* NOTE: THE PLANNING APPROVAL
UNDER REF NO 73044/APP/2020/700
DATED 27/04/20, CHANGES MADE
AS FOLLOWS:

KUMAR TALPADE CHARTERED ARCHITECT DNT DESIGN SERVICES LTD 86 ALBURY DRIVE PINNER, HA5 3RF	REVISIONS		OWNERS : MR. VIVEK SHARMA	3 MEZEN CLOSE NORTHWOOD, HA6 2DP
	NO	DATE	PLANS AS PROPOSED	RENEWAL of PLANNING APPROVAL WITH MODIFICATION
	A	REDRAFTED PLANS 8/02/20		
	B	REVISED AS SUGGESTED BY THE CLIENT 12/02/20	F - ADDED	SCALE : 1:100 (A3) DT: 8/02/20 DRG NO: DNT/3 MEZ./P/10
	C	REVISED USE OF KIT 4 STUDY 14/07/20		
D	WINDOW TO STUDY HT REVISED 8/8/20			
E	NOTES ADDED EGRESS WINDOW 8/11/20

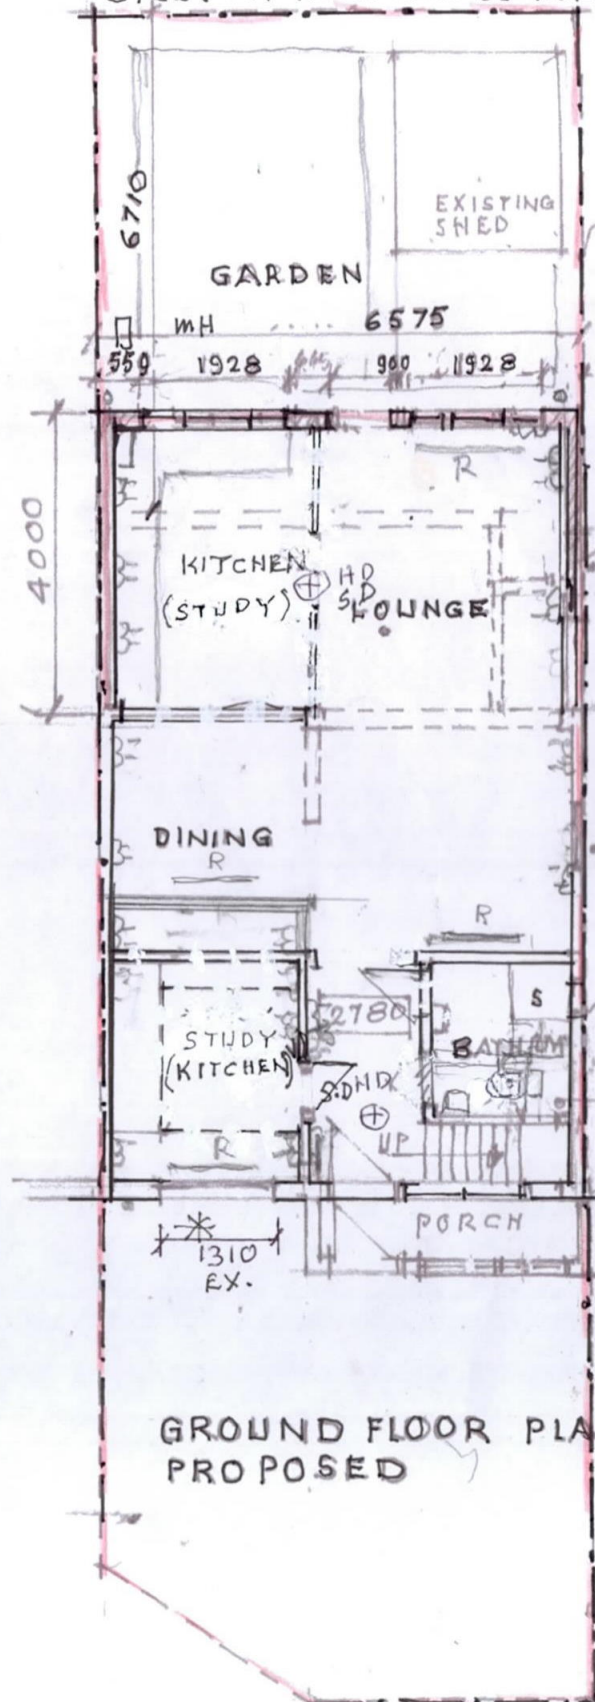
- * KITCHEN IN FRONT WILL BE USED AS STUDY
- * STUDY AT REAR WILL BE USED AS KITCHEN

FRONT ELEVATION

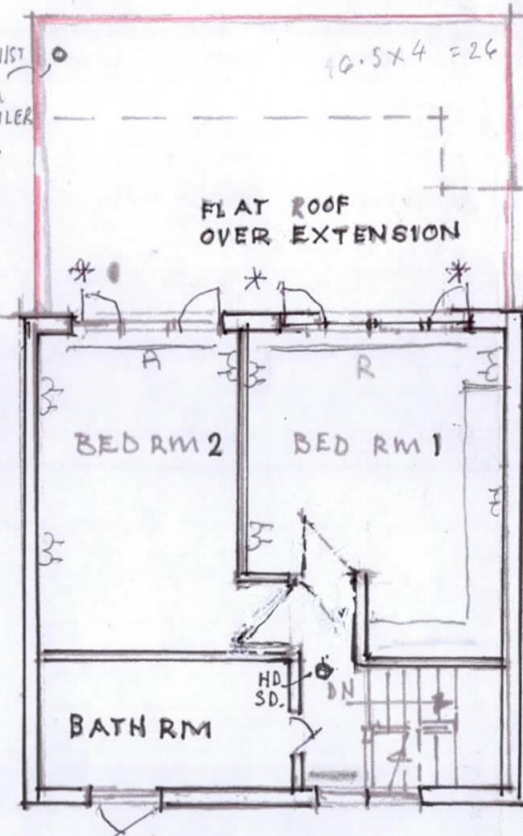
* EGRESS
WINDOW
OPENING 500
CILL 900

* REVISED HEIGHT OF WINDOW
TO STUDY.
